14MP
14 Milton Place
Gravesend
DA12 2BT
Kent

Interior refurbishment
Listed Building Consent 20250269

Details showing how the insulation boards will be installed in relation to the skirting boards and architraves.
Sash windows with architrave:
-Bedroom 1, 2, 3, 4
-Kitchen
-Reception room

14MP10/PR **Rev.2**

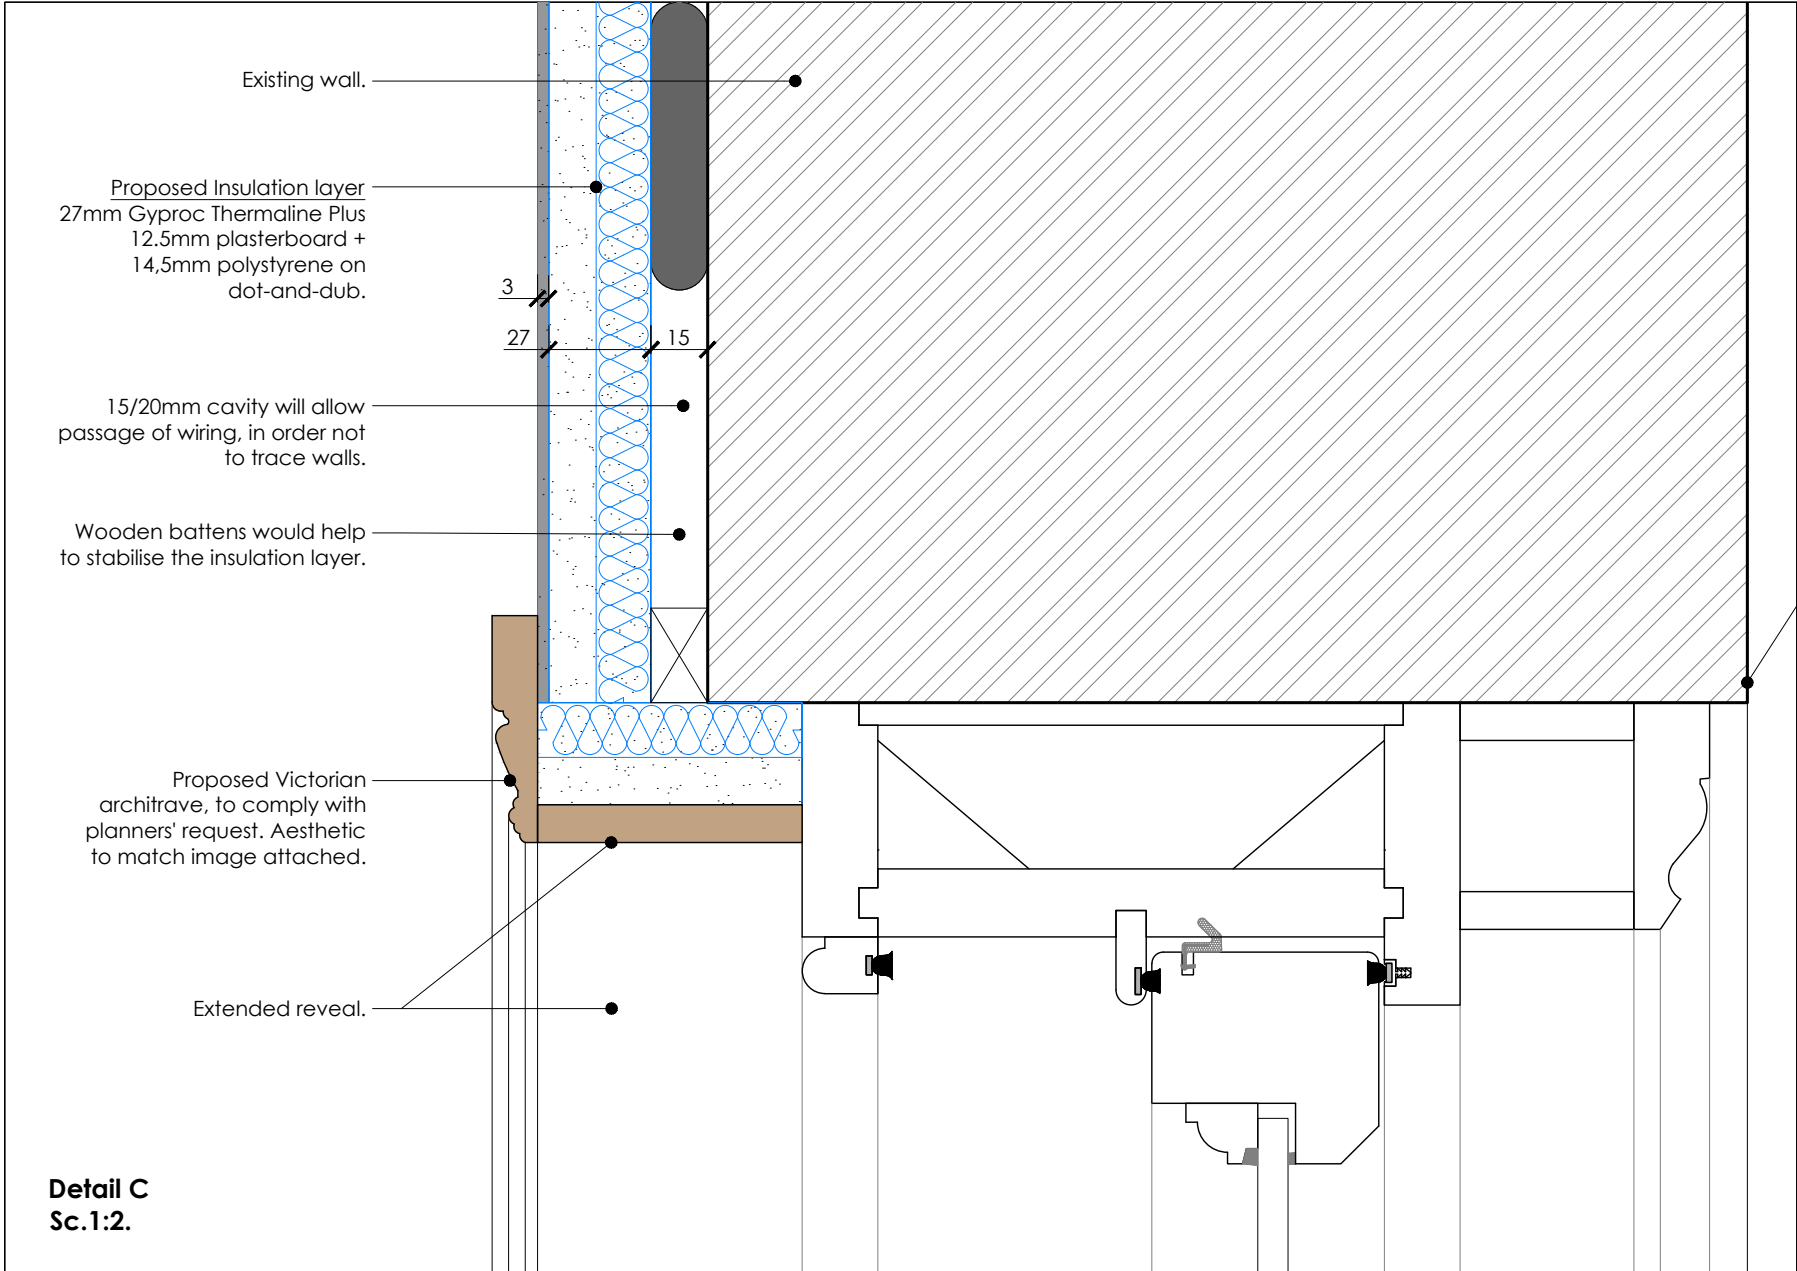
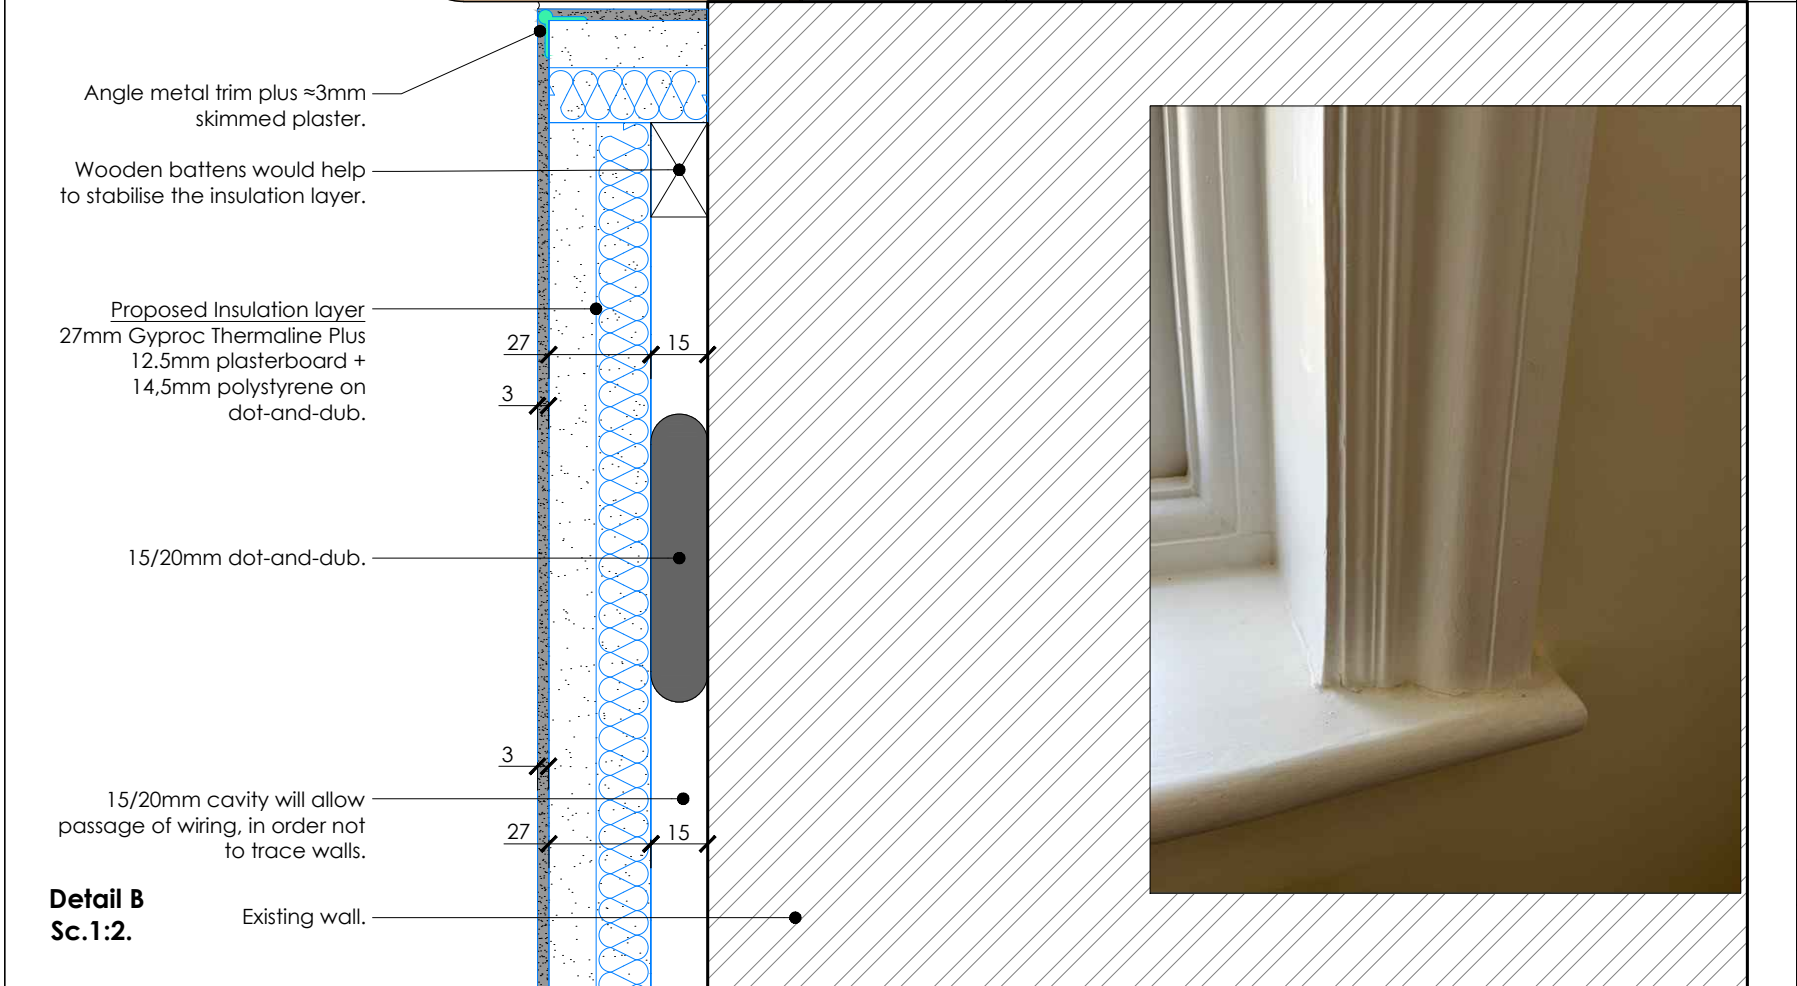
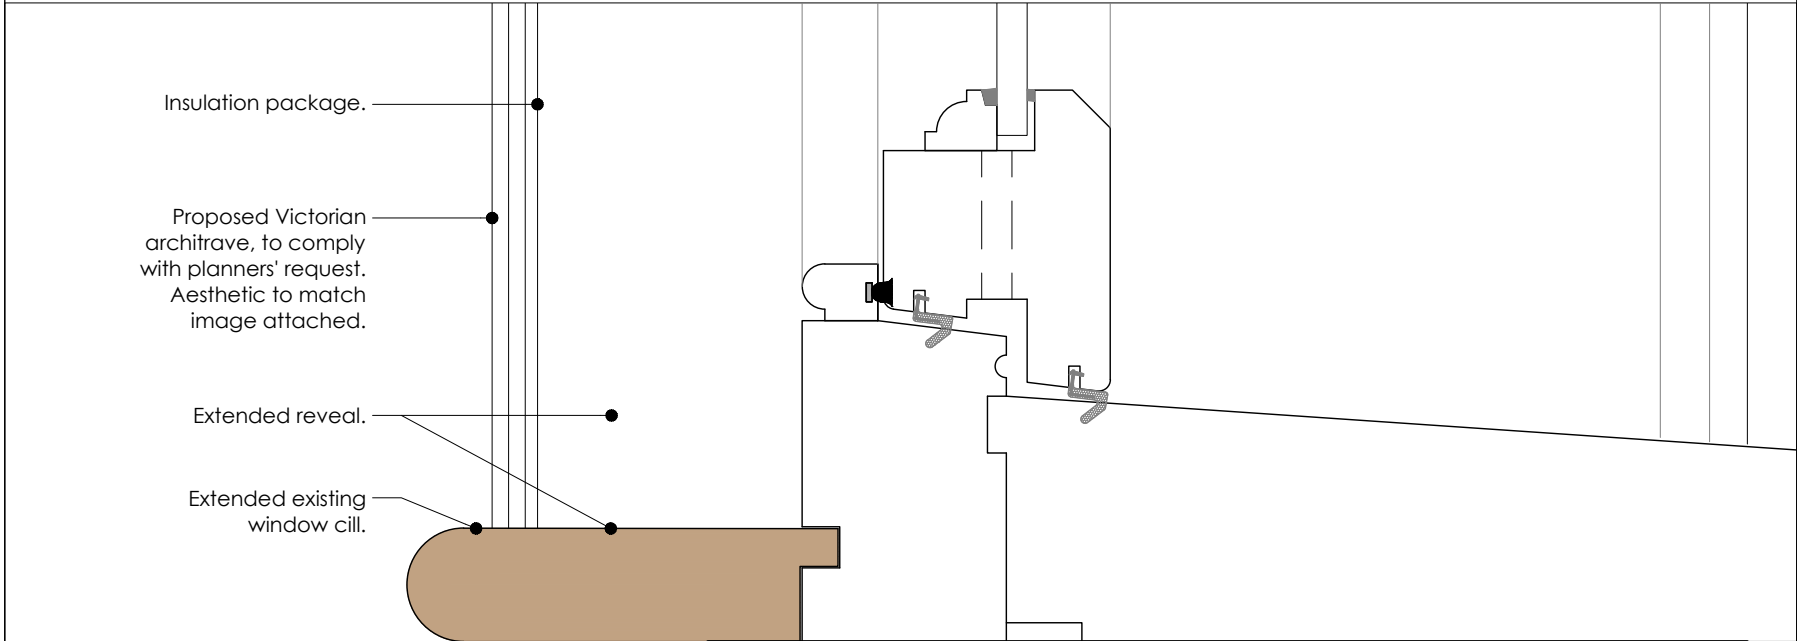
- Revisions:**
- 10/07/2025 - Rev.1**
-Window's reveals adjusted by extending the window cill and reveal board with an Victorian architrave.
-Proposed new Victorian skirting board , as per planners' suggestion.
- 23/07/2025 - Rev.2**
-Windows architraves' setting amended as per planners' request.
Architrave to be added also to Bedroom 2, 4 and Reception room.
